## Background to this request

## Responses related to the Manchester TMA

## Responses related to the Scottish TMA

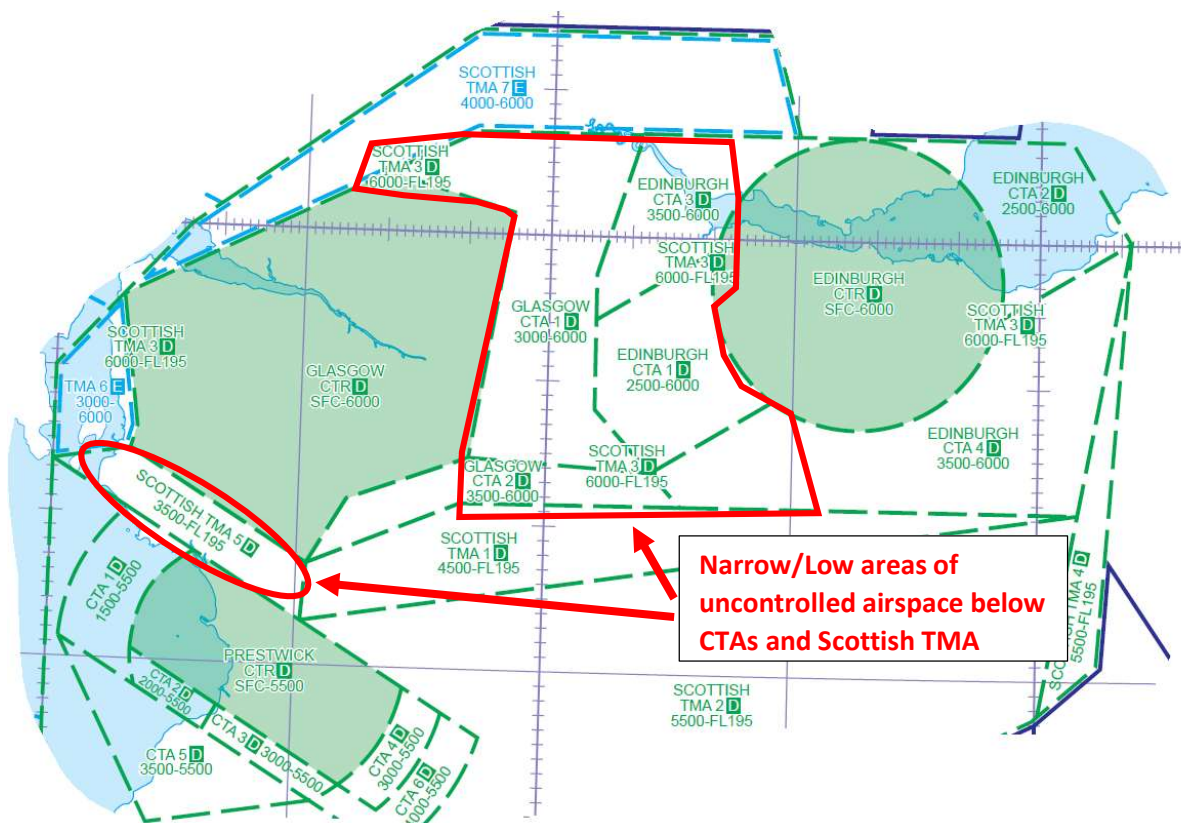
- A couple of responses mention that the uncontrolled airspace below Scottish TMA 5 is too narrow between Prestwick and Glasgow CTRs. GA pilots are having to be extra vigilant due to the high concentration of GA traffic in this small area of airspace, the responses have requested a base level increase for Scottish TMA 5, and also for the airspace to be widened into the Glasgow CTR to increase the gap.

- A few other responses point out the narrow and low area of uncontrolled airspace below the Scottish TMA and various CTAs between Edinburgh and Glasgow CTRs. This area currently prohibits a lot of gliding activity transiting between Scotland and the North of England. The responses request to make the corridor wider and higher to better allow transiting glider flights. Currently the only other way round this airspace is over large areas of water, which from the responses, is looking to be avoided.

- A couple of other responses mention that due to high terrain in the North of the Glasgow CTR, this area is not used by commercial traffic due to terrain clearance, and therefore the SFC-6000ft in the northern part of the Glasgow CTR should be re-classified. One response requested expanding Scottish TMA 7 South into the Glasgow CTR and making everything below the expanded Scottish TMA 7 Class G airspace. The higher terrain providing thermals for gliders.

### LTMA 3

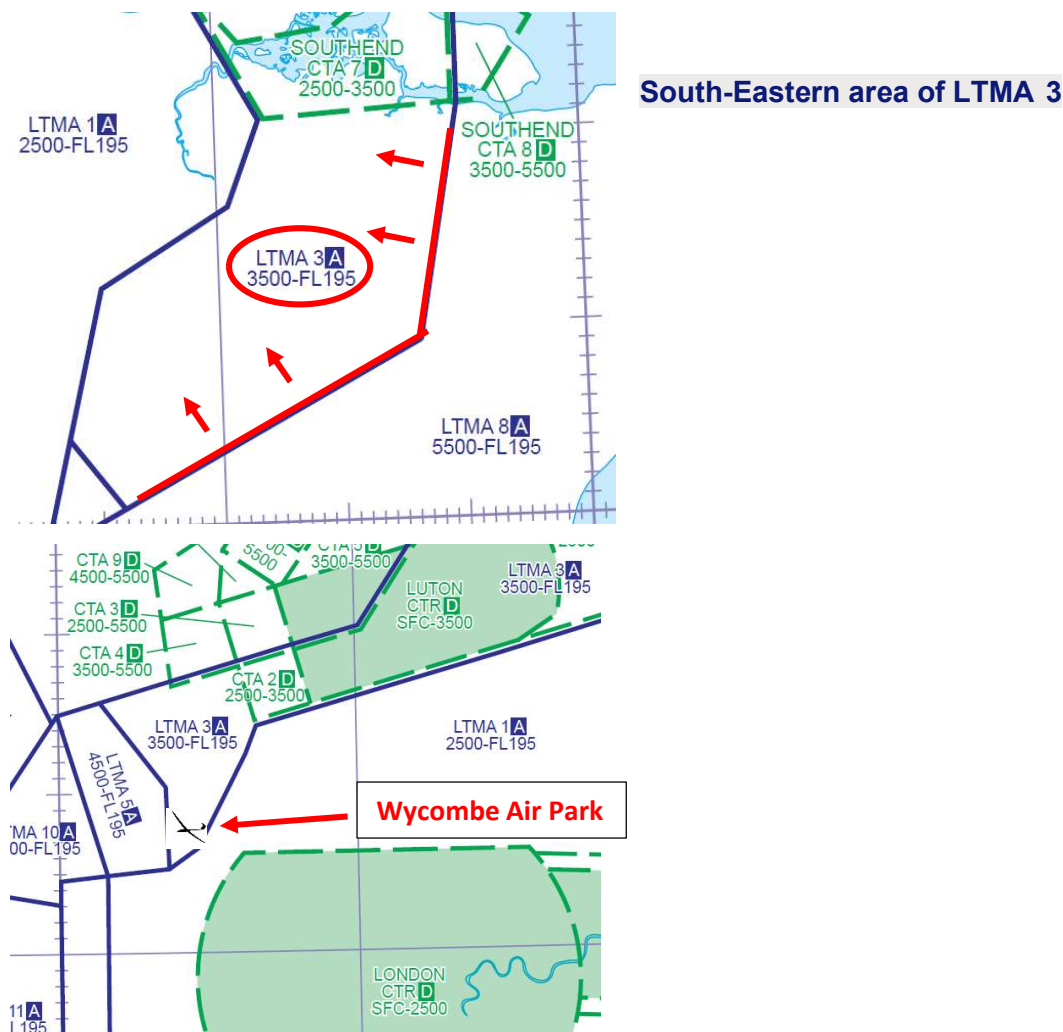
- Most of the responses are highlighting the South-Eastern part of LTMA 3 as underutilised by commercial traffic, and that the base level should be raised to 5500ft to allow better cross country opportunities for gliders and improve the height range without having to route much further south and avoid field landings.

- Some of the responses are requesting for the boundary with LTMA 8 to move North-Westwards to increase the base level of the airspace above the Kent/Sussex area currently within LTMA 3.

- The responses mention a lot of GA activity within the South East area of LTMA3 with various GA airfields and a busy glider club.
- Other responses mention the airspace of LTMA 3 above Wycombe Air Park does not provide a high enough base level for training flights above the airfield and the town.

- The responses for Wycombe would like to see the LTMA 3 area here raised to 4500ft and have noticed no commercial traffic using this piece of airspace at this level.

- A couple of other responses mention a Letter of Agreement which temporarily allows the airspace above Wycombe Air Park to be raised during glider competitions to 4500ft. The responses ask why the airspace here cannot be raised permanently to 4500ft.

## LTMA 4 & LTMA 20

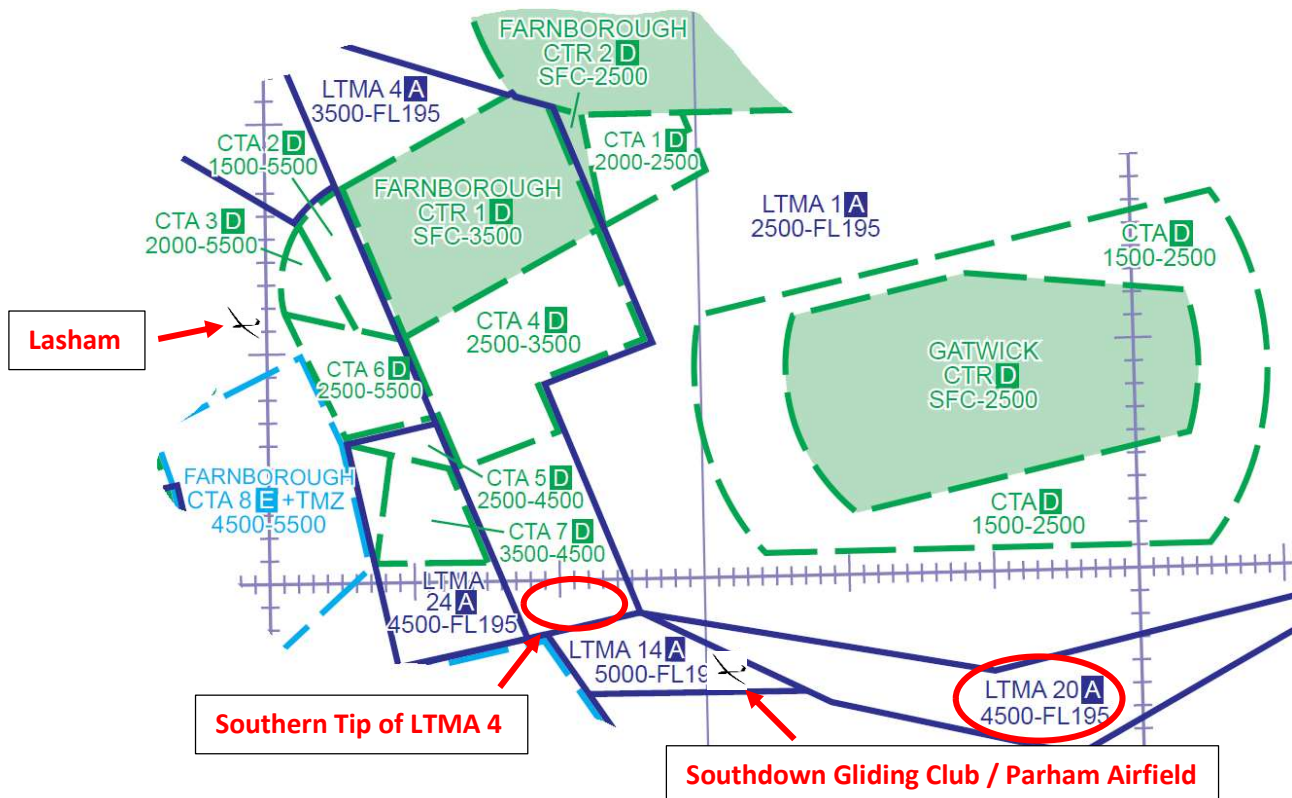
- Most of the responses for LTMA 4 and LTMA 20 are highlighting the same issues.
- The responses referring to the Southern tip of LTMA 4 want the base level of this airspace raised to 4500ft.
- The responses referring to LTMA 20 want the base level of this airspace raised to 5500ft.
- The responses say the extra height requested in both LTMA 4 and LTMA 20 will help when soaring conditions fade during the afternoon and assist returning glider flights. They also mention the extra height will also help separate all other GA traffic from gliders.
- The responses all highlight issues with gliding below controlled airspace, particularly for gliders operating between the South Downs gliding club and Lasham.
- Concern has been brought about by the new controlled airspace structures around Farnborough making transiting glider flights difficult between the two glider sites.
